Safety Notice Mandatory Action Required	200004

Date: January 29, 2020

Subject: Turntable Rotation Bearing Bolts

- 1 Bolts, PN 1256170GT
- 2 Washer, PN 1256182
- 3 Turntable rotation bearing

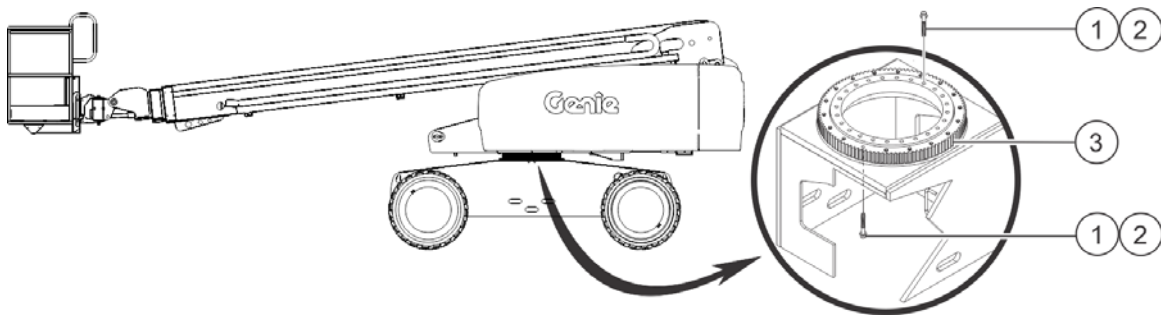
Genie has been notified of three instances where the bottom turntable rotation bearing bolts in the machines referenced above have come loose causing the separation of the turntable from the chassis. **Separation of the turntable from the chassis can result in a machine tip-over or other structural failure.**

- 1 Locate the affected machines referenced above within your fleet.
- 2 **Machines with a year of manufacture 2019 up to the release date of this notice (see Table 1):**
 - Remove the machine from service.
 - Following the instructions starting on page 3, confirm that each turntable bearing bolt is torqued to specification.

- As soon as possible but no later than 30 days from receipt of this notice and following the instructions starting on page 3, confirm that each turntable bearing bolt is torqued to specification.
- 3 Return the machine to service.
 - 4 Fill out and sign the attached completion form and return to Terex AWP Warranty Department or file a warranty claim online to verify that this Safety Notice has been completed.

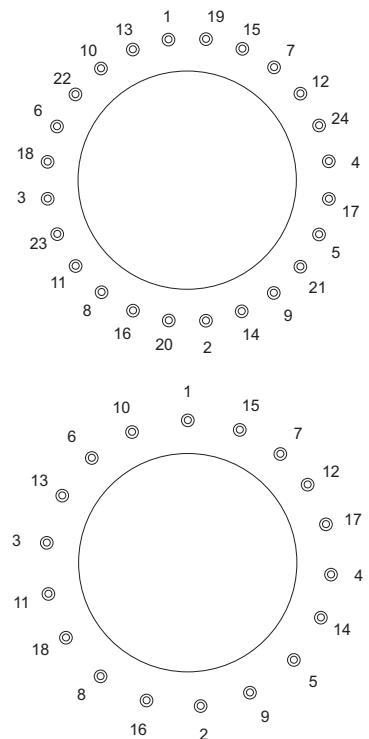
Crushing hazard. Keep hands away from the cylinder and all moving parts when lowering the boom.

- 1 Raise the (primary) boom and place a safety chock on the lift cylinder rod. Carefully lower the boom until it is 1 inch / 2,5 cm from the lift cylinder safety chock OR support the boom assembly with a suitable lifting device.
- 2 Turn the key switch to the off position.
- 3 Using a star pattern, confirm that each upper turntable rotation bearing bolt (24 X) is torqued in sequence to the specification.

Torque Specification = 180 ft-lbs / 244 Nm

- 4 Raise the boom and remove the safety chock OR lifting device.
- 5 Lower the boom to the stowed position.
- 6 Using a star pattern, confirm that each lower turntable rotation bearing bolt (18 X) is torqued in sequence to the specification.
- 7 **Torque Specification = 180 ft-lbs / 244 Nm**
